**COMMENTS TO THE ENVIRONMENTAL COMMISSION
ON THE ZILKER PARK ACL STAGING AREA AND PARKING LOT PROPOSAL
from the Zilker Neighborhood Association (June 20, 2018)**

Screenshot of TCAD map showing the proposed project property tract (PID 105461) and the two Great Lawn tracts (PID 105462 and PID 105144)

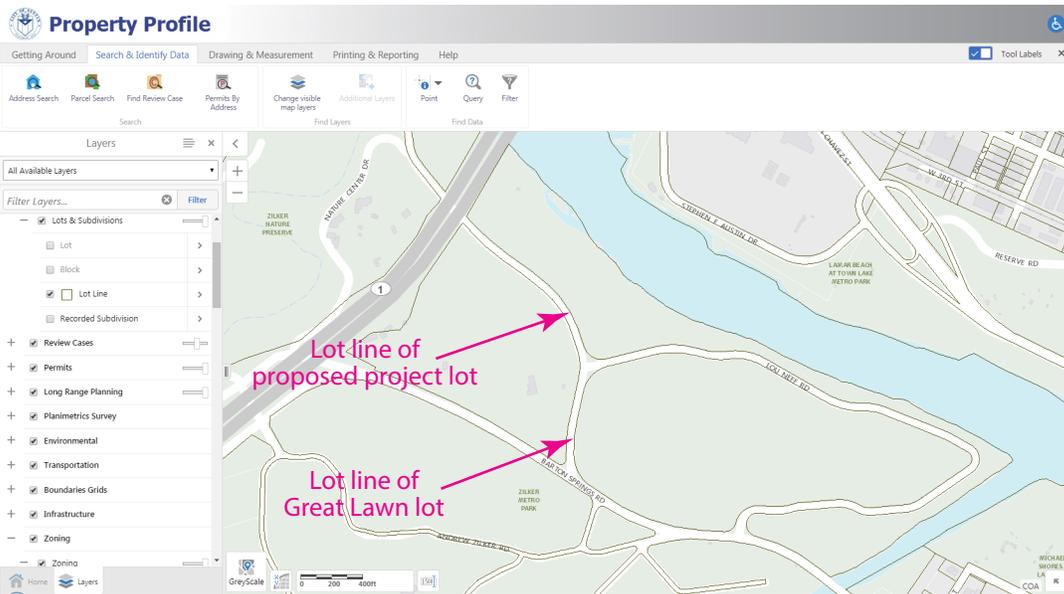
In the 15 May 2018 Site Plan submittal, the applicant added two TCAD tracts (the Great Lawn tracts) to the total tract area in an attempt to solve the impervious cover problem in the 23 Mar 2018 submittal. So, the total tract area no longer includes just the TCAD tract and City lot upon which the proposed parking lot sits which is the normal method of determining impervious cover percentages. It also includes the Great Lawn. No justification for this change was provided. The sole purpose seems to be to add enough additional land to the overall area so that the secondary setback impervious cover calculation would produce a value that is less than the maximum 30%. As a result of inappropriately adding these additional lots, the applicant was able to calculate the proposed impervious cover in the secondary setback as 20.9%.

BUTLER LANDFILL PARKLAND WEST OF MOPAC BRIDGE

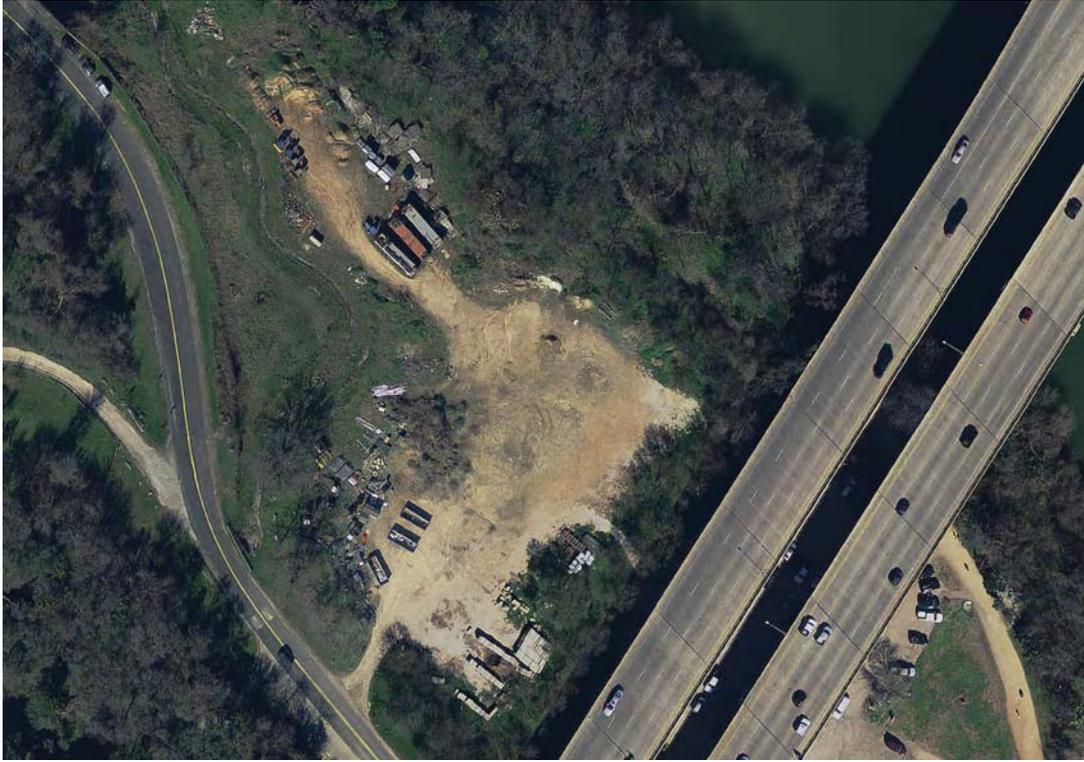
1) The landfill along Stratford on the west side of MoPac has been turned into a junkyard with construction debris and discarded materials from PARD and visible rutting caused by vehicles (see Attachment B). ***If PARD is concerned about the integrity of the landfill and damaging the landfill cover, why are damaging activities allowed to continue on the west side of MoPac?***

Map from Watershed Protection Department showing landfill boundaries extending under Zephyr railroad tracks and eastern wetland area.

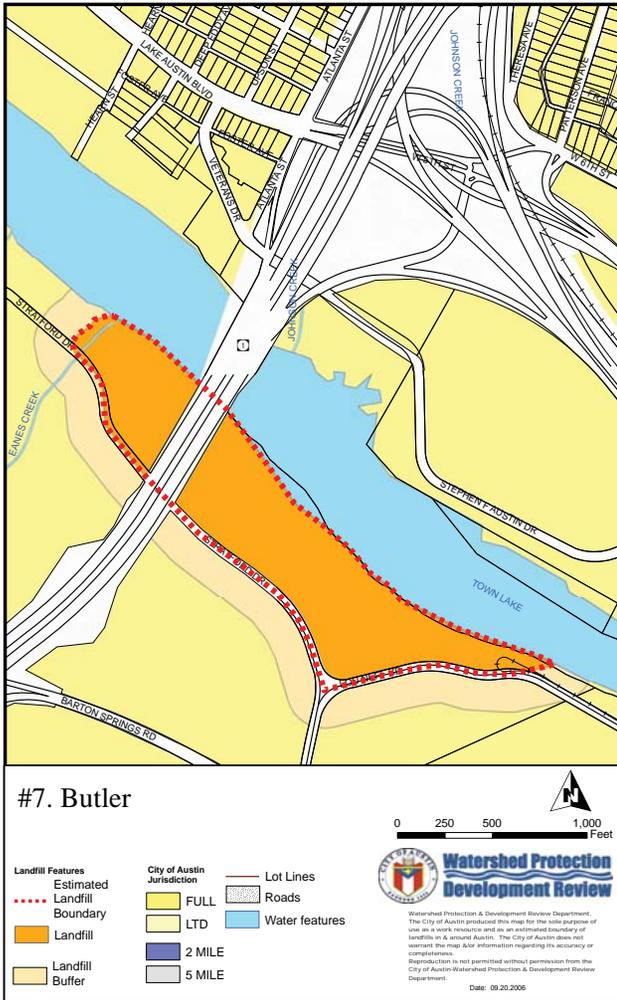
2) There are two wetland areas which currently exist over the landfill, although in some recent maps submitted in support of this project, part of the landfill has been eliminated (see Attachment C). ***Why has the most eastern portion of the landfill been eliminated from the landfill boundaries? Is there any evidence that the landfill does not extend to the Zephyr railroad tracts as originally determined in early site assessments? If PARD and the Watershed Protection Department (WPD) believe that wetland areas should not exist over closed landfills, why are they only concerned with the western wetland area and why is nothing being done about the eastern wetland area which is also over the landfill?***
